PURPOSE : INFORMATION	ISSUE NO. : MSB-07E42-012	DATE : 2007-11-05
SUBJECT : HOOD WEATHERSTRIP AND HOOD WEATHERSTRIP FRONT	<div> <div><MODEL></div> <div>(EUR)</div> <div>OUTLANDER</div> <div>(GS45X)(CW0W)</div> </div> <div> <div><M/Y></div> <div>07, 08</div> </div>	
GROUP : BODY

BODY
HOOD

HOOD

REMOVAL AND INSTALLATION

M1421001601207

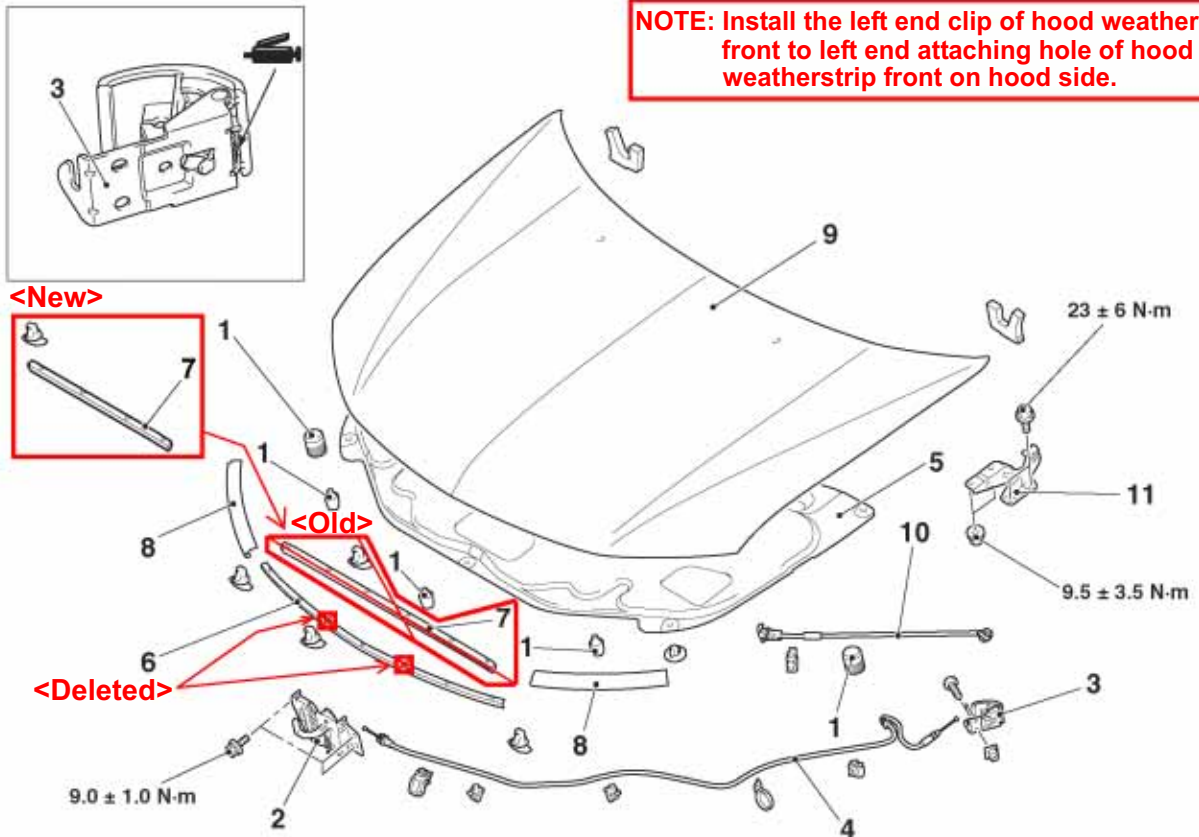
In order to improve the productivity, the hood weatherstrip and the hood weatherstrip front are modified. This Service Bulletin contains the following changes.

- The number of the clips, which fix the hood weatherstrip, is changed from 7 to 5.
- The length of the hood weatherstrip front is changed from 698 mm to 437 mm.
- The number of the clips, which fix the hood weatherstrip front, is changed from 6 to 4.

AC605071AD

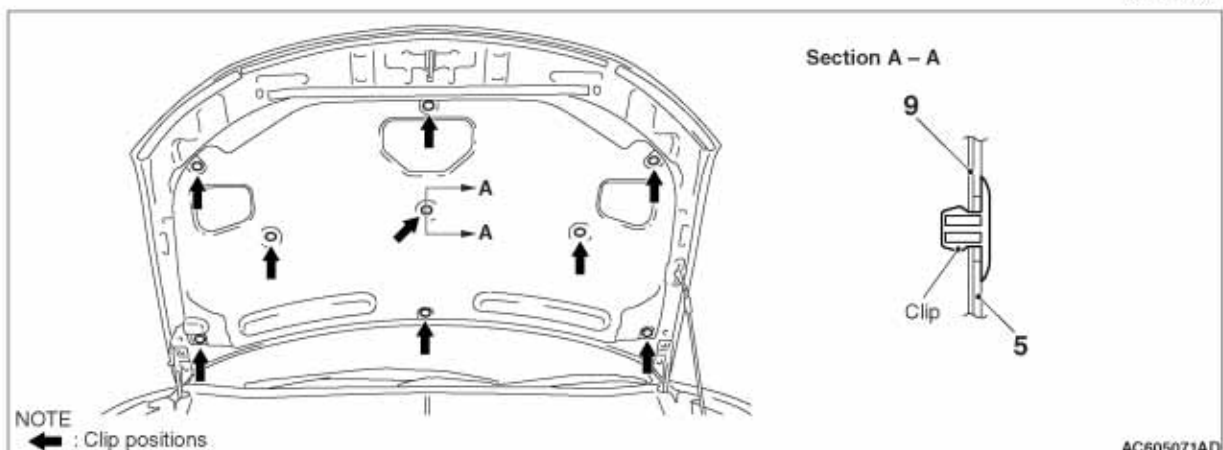
<Added>

NOTE: Install the left end clip of hood weatherstrip front to left end attaching hole of hood weatherstrip front on hood side.
